WILLIAMSON COUNTY, TEXAS  
CHANGE ORDER NUMBER: 5

HNTB Corporation  
Project: R603-062 Rock  
Roadway: CR 258  
CSJ  
Number: Received  
MAR 09 2017

**CR 258**

**Change Order No. 5**

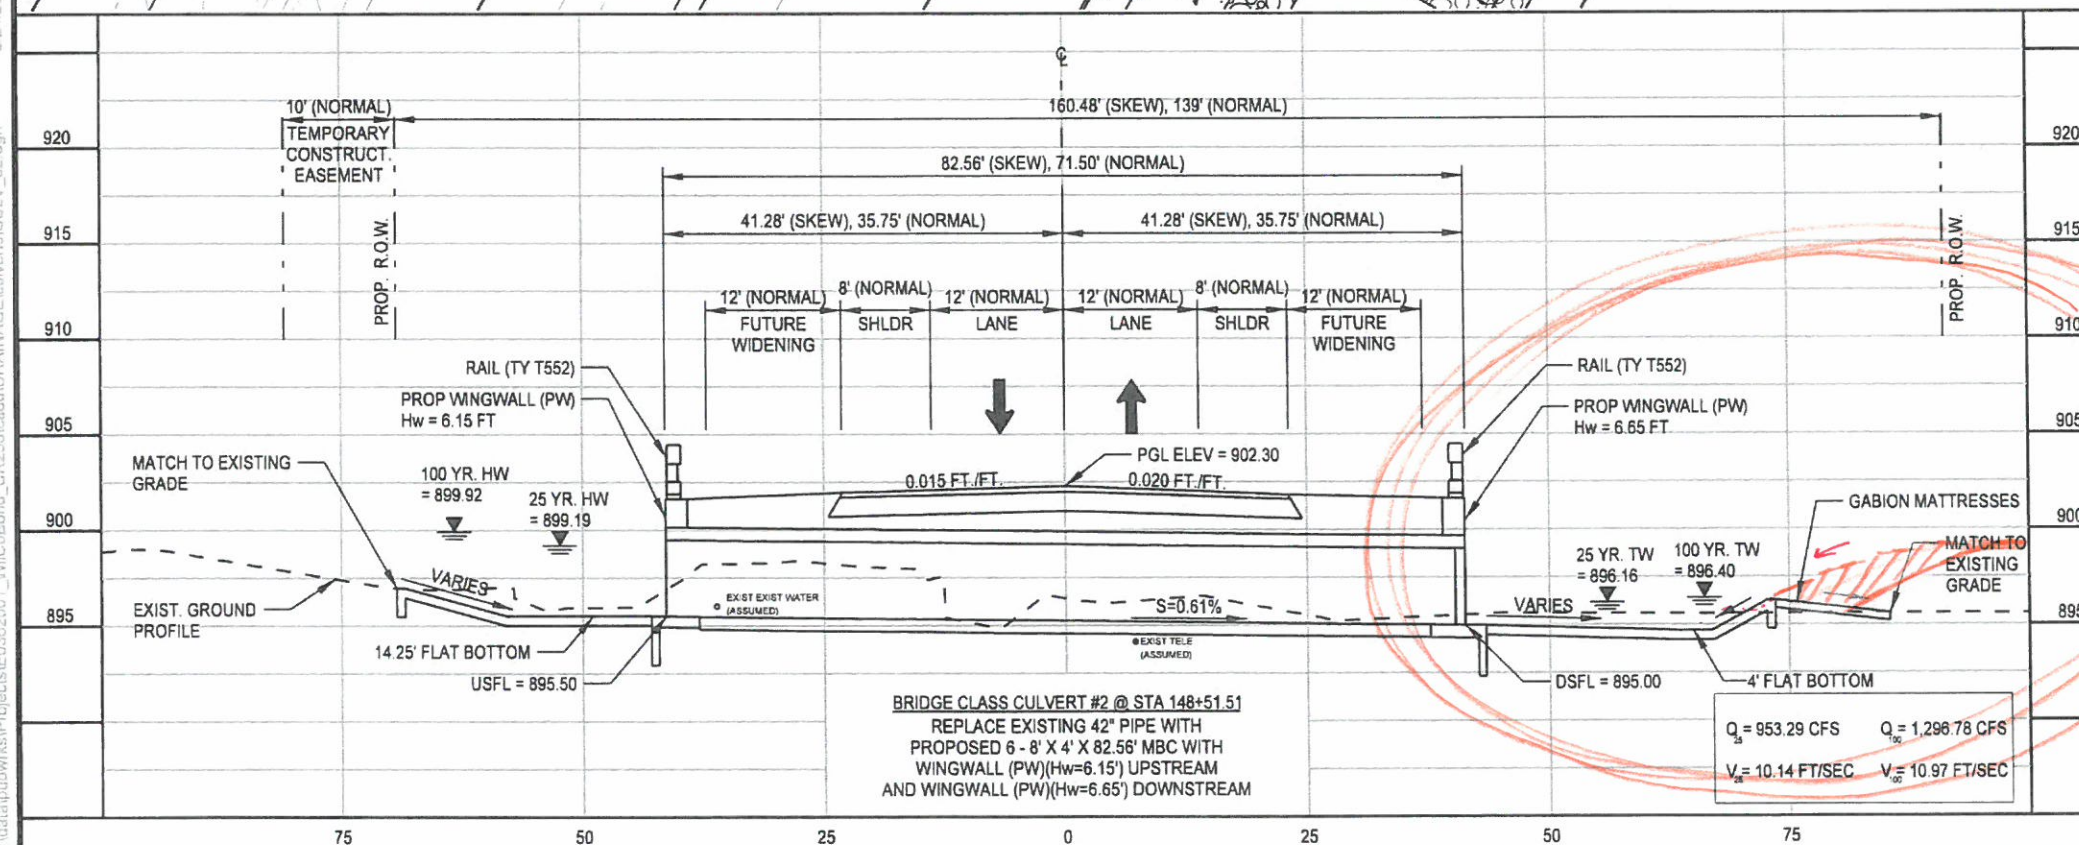
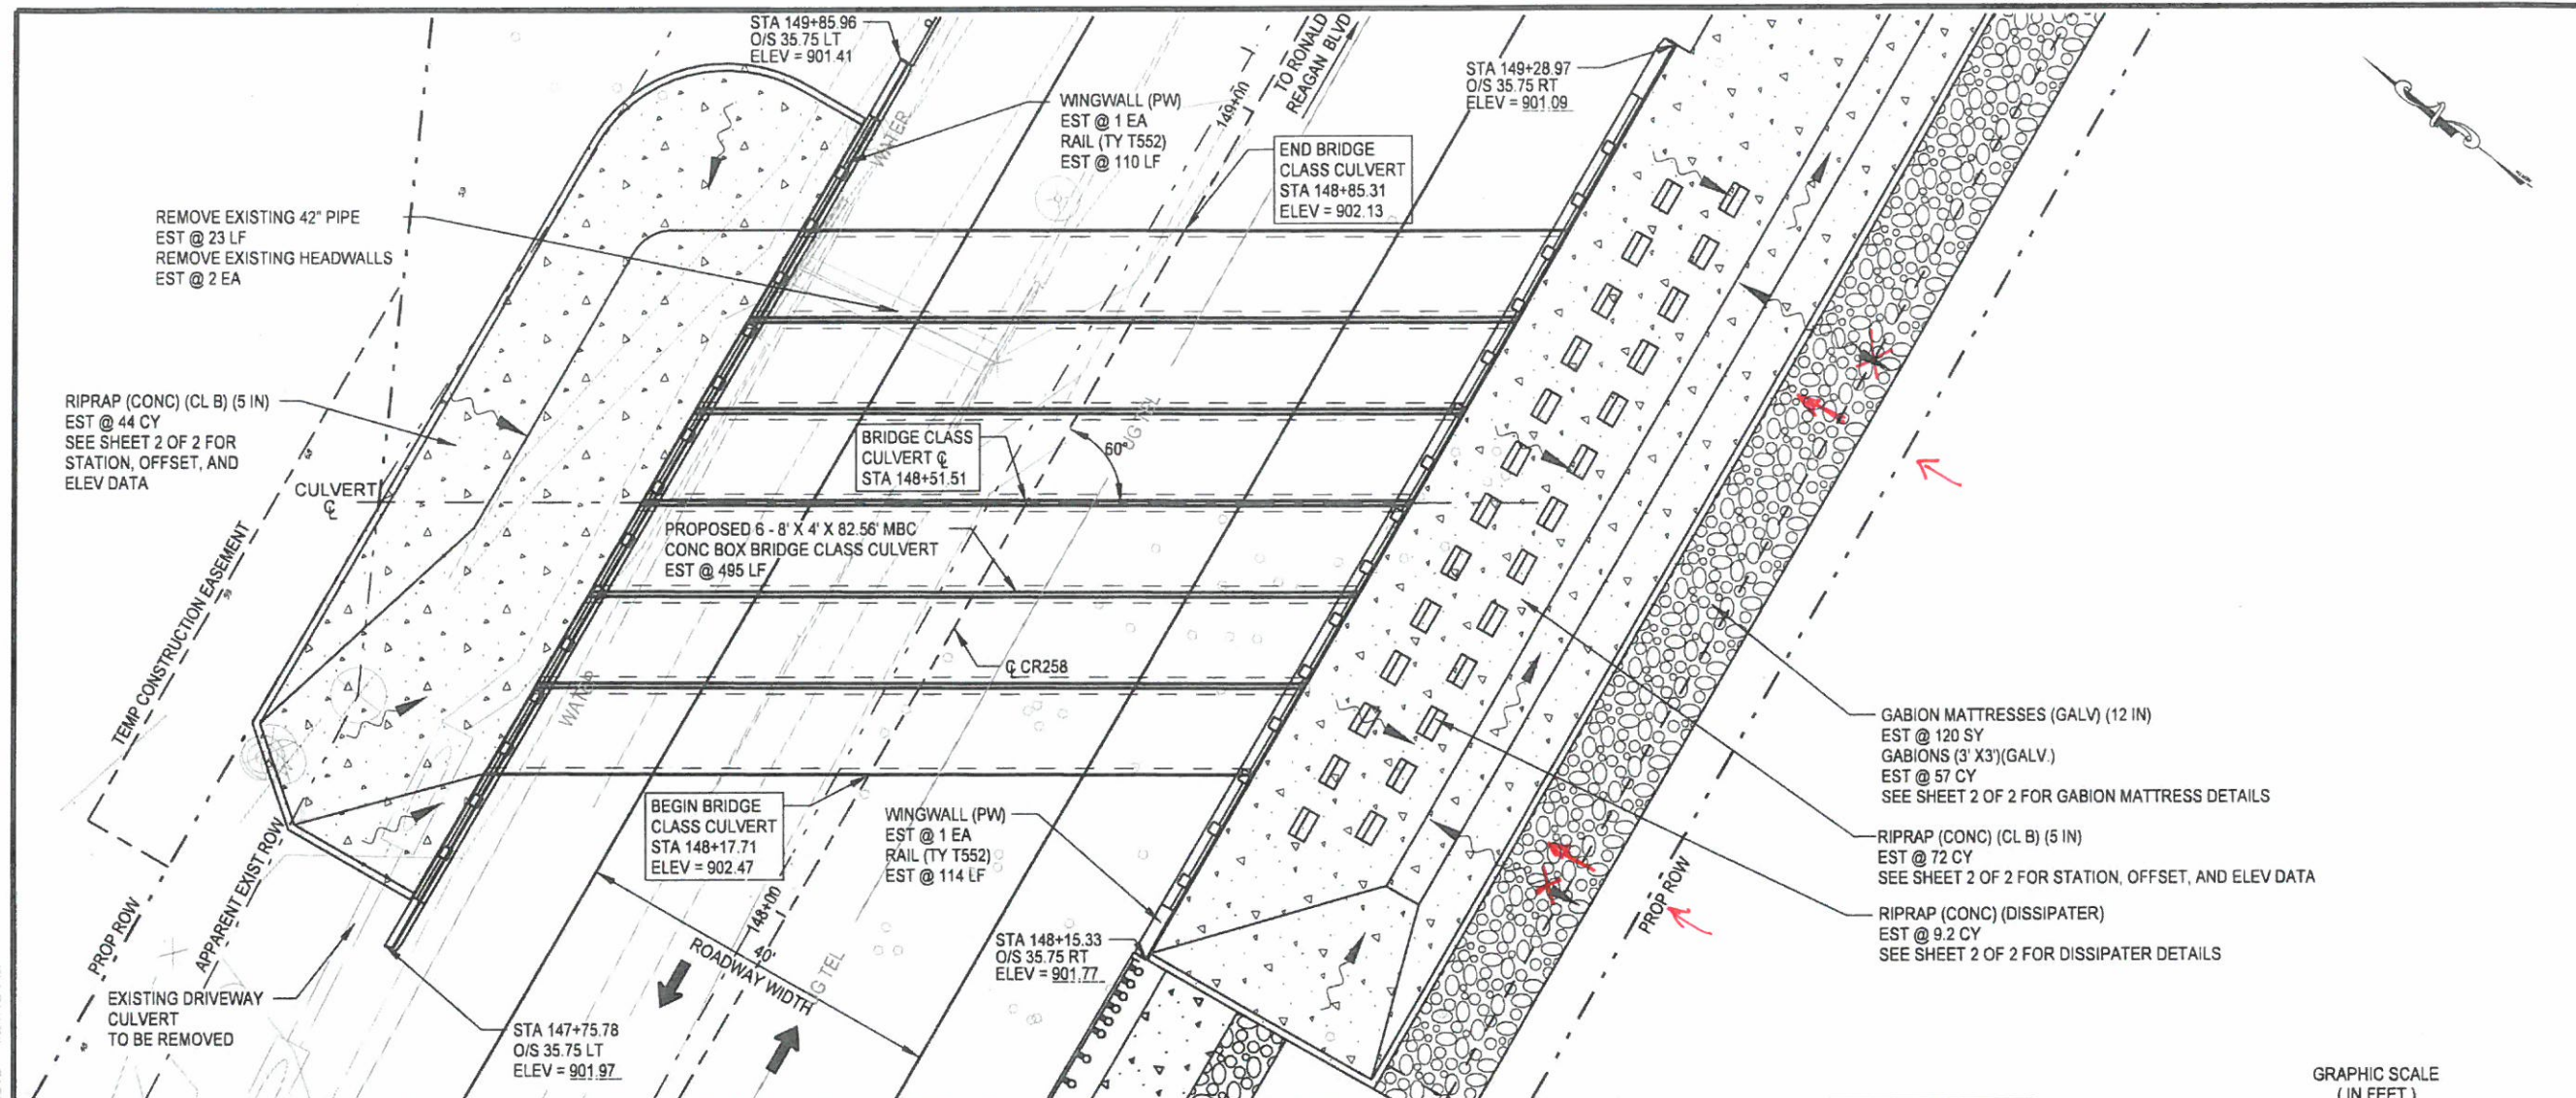
**2J: Differing Site Conditions. (unforeseeable) Other.** This change order revises various erosion control measures on the project including the addition of soil retention blanket to the contract to prevent erosion and help to establish vegetation quicker on the slopes and in the ditches. **3H: County Convenience. Cost savings opportunity discovered during construction.** This change order replaces the 12" Gabion mattresses with Flexamat. The use of this product was approved by the County Road and Bridge Department. The 3' x 3' gabions were deleted due to changes at the downstream end of Culvert #2.

This change order revises various erosion control measures on the project. Soil Retention Blanket was added to the project to promote timely vegetation establishment and to prevent erosion on the long 3:1 slopes along the project. Flexamat was added to replace the 12" gabion mattresses in the ditch from Sta.135+86 to 148+15 Rt. The use of Flexamat was approved by the County Road and Bridge Department and the Design Engineer. Road and Bridge wanted to try a new product that is a cheaper alternative to the gabion mattresses for the same applications. The 3 x 3 gabions were deleted from the project due to a change in the grading by the property owner that is downstream of Culvert #2. The downstream property was raised at the right of way line and the slope will be stabilized with concrete riprap instead of the gabions.
